Comments and/or Proposals regarding to The Revision of GTR22

- 1.V2X verification method & corrective action procedure
- 2.Proposal “**NOT** to the deletion of MPR_Matrix”

prepared by JAPAN

66th EVE IWG

MPR Matrix Concept

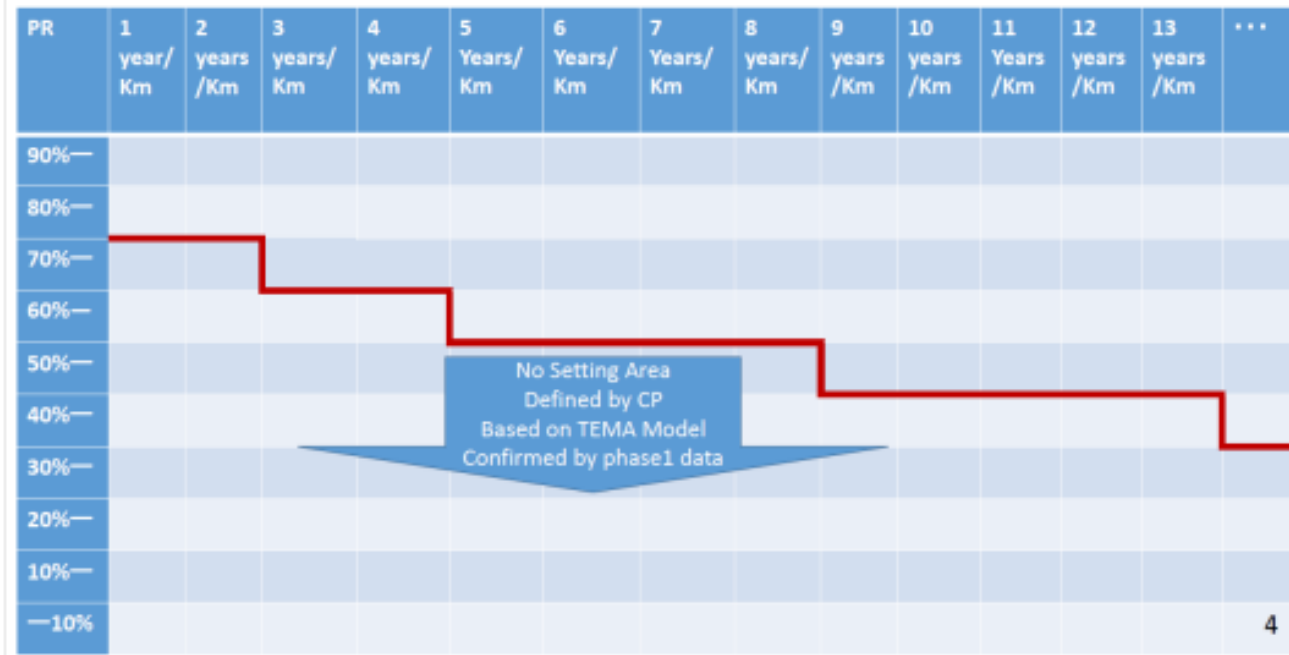
This was proposed by Japan in the EVE40 (EVE 40 -03e) for phase 2.

add a "placeholder" Annex 2, titled "RESERVED: Annex X/MPR matrix", containing text.] such as
[In Phase 2, the substandard areas will be defined and each CP can decide MPR]

This proposal was not included in the Draft of GTR for Phase1 with the following comments which were added after the last IWG. However, Japan is also proposing this concept from the point of view of the harmonisation (see P7, 8, 9, 10).

There is no need for an Annex, since the sentence above Table 2 states that the values shall be monitored to inform the 2nd phase. But we should definitely not add that each CP can decide MPRs. This would be against harmonisation.

Suggested Statement in Technical Report: Example of MPR Expression Considering CP Situation

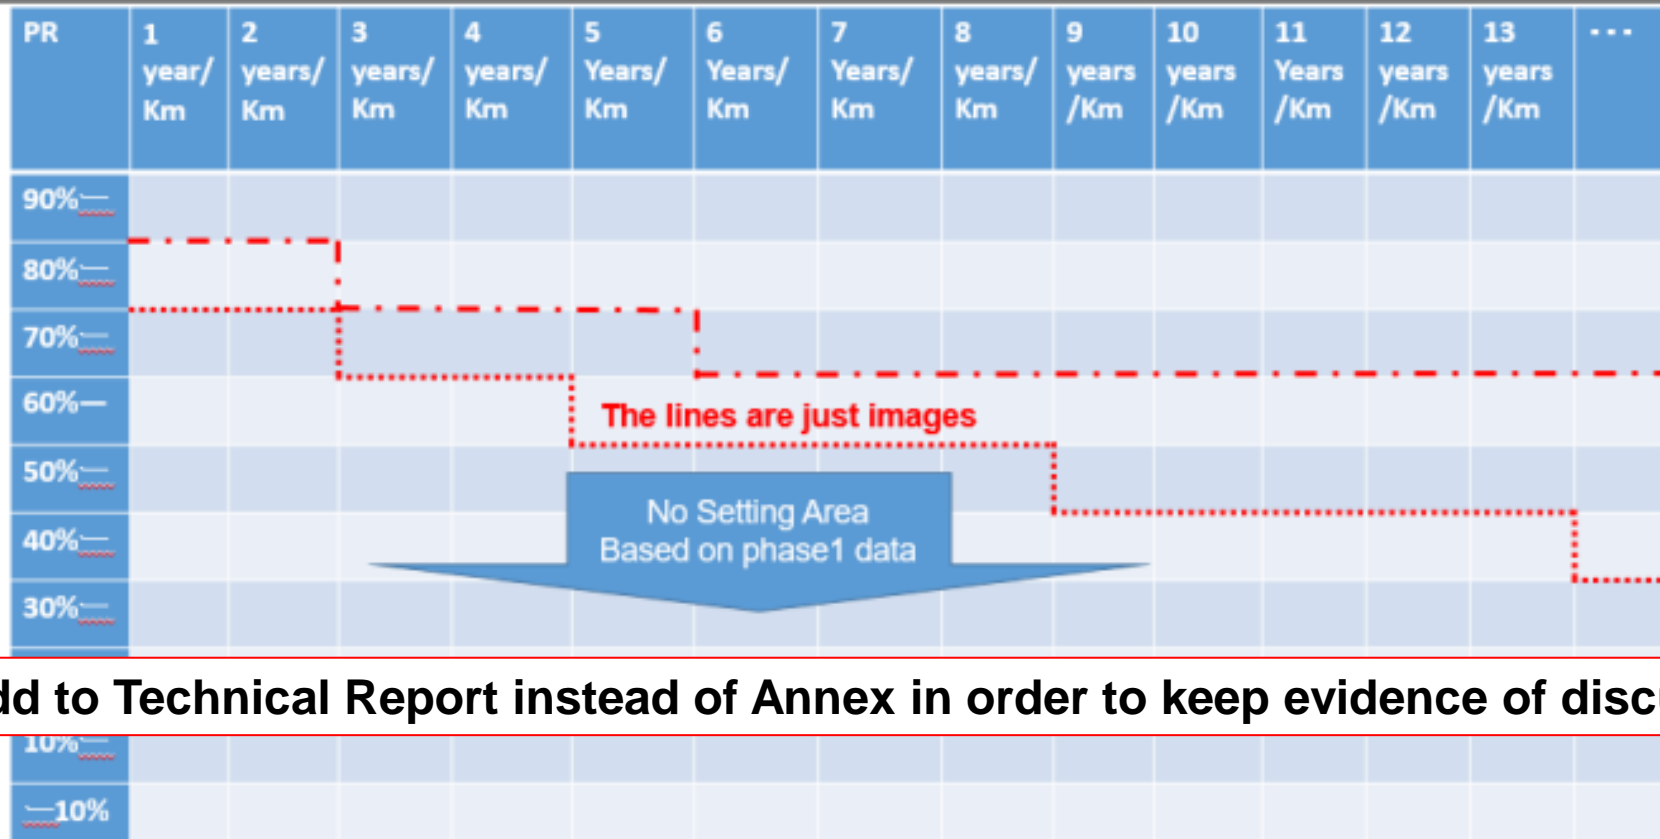
1. For Phase 2.
2. Based on the data collected by the unified evaluation method in Phase 1, and data from many countries and regions, it is expected that it will be possible to develop additional substandard battery criteria according to mileage and years, and.
3. Considering that the situation varies by country or region, CPs can select appropriate MPR for their specific market, as long as they are above the substandard battery criteria line.

Proposal to add to Technical Report instead of Annex in order to keep evidence of discussion.

Sample of MPR Matrix ←

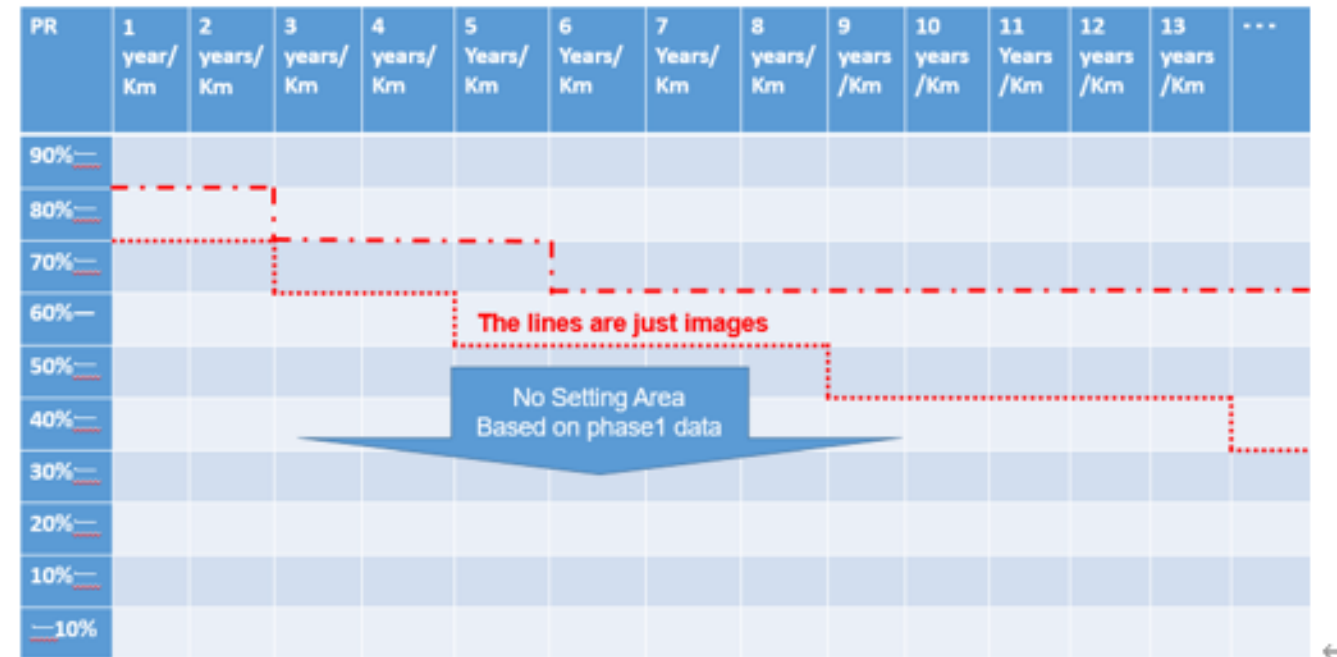
4338. The new MPR setting concept as depicted with the matrix below, figure XX, was proposed by Japan in order to let each contracting party decide its own MPR as option. The matrix exemplified the area to be defined as substandard category of MPR and the area that the MPR can be determined. ←

The IWG considered this proposal and decided to not adopt it during the first phase. ←

Plan to propose “Matrix concept” described in EVE43-03e ←

JPN plan to provide the concrete text by May 18th IWG meeting ←
